# RESPONSE TO RFI

**Address:** No. 24 Coronation Road, Congarinni North

**Proposal:** Seniors Housing Development

**DEVELOPMENT APPLICATION 2021/056/1  
NO. 24 CORONATION ROAD, CONGARINNI NORTH**

**FIGURE 2**

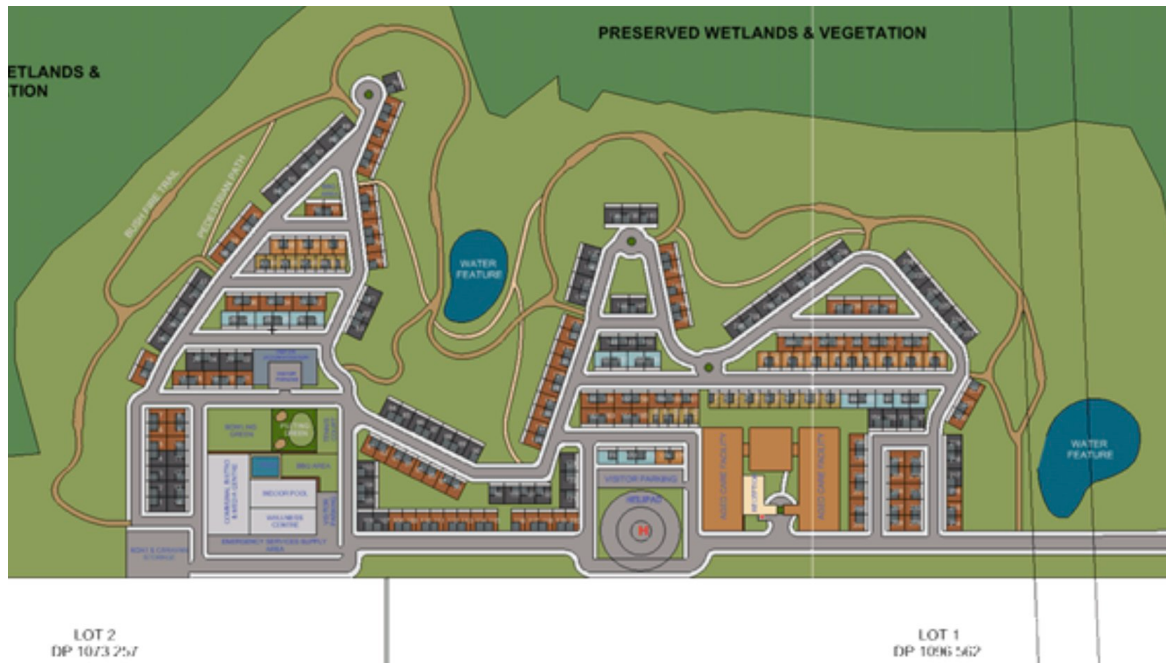
The Assessment concluded that the potential of the development proposed for 24 Coronation Road to spark land use conflict with agricultural uses in the surrounding vicinity was low. Council

accepted this conclusion and supported rezoning of the land to allow seniors housing according with a Concept Proposal – see Attachment 1 to the Ordinary Council Meeting dated 27 October 2016 and reproduced below, illustrating dwellings setback appropriately 35 metres to the southern property boundary.

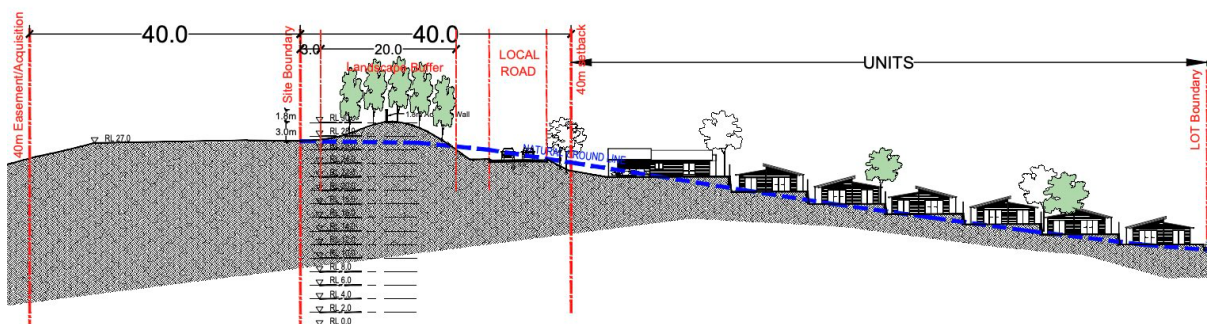
Council has raised concern for the potential of adjoining sites to be used for horticulture, and specifically the propagation of blueberries. This has been confirmed through discussions with the owners of Lot 2 DP 12655232, No. 160 Coronation Road (Brarz).

Blueberry plants grow slowly, and it takes 2 or 3 years before the bush is ready to produce flowers and fruit for the first time, and about 6 – 10 years to reach mature size. It is further understood that the product must be hand-picked by people who know how to spot a ripe blueberry, meaning the industry is labour intensive rather than mechanised.

This time to establish the blueberries and for first fruit to appear would enable time for the establishment of a suitable vegetative buffer.

Following the identification by Council of this concern, we have met with both land owners to the south (Brarz and Usher) and reached in principle agreement for the establishment of a 40 metre buffer across each of these respective properties, which is to be excluded from horticultural development, including any access by farm machinery such as tractors on a frequent basis. This is to be achieved via the imposition of a restriction on title as may determined appropriate by Council.
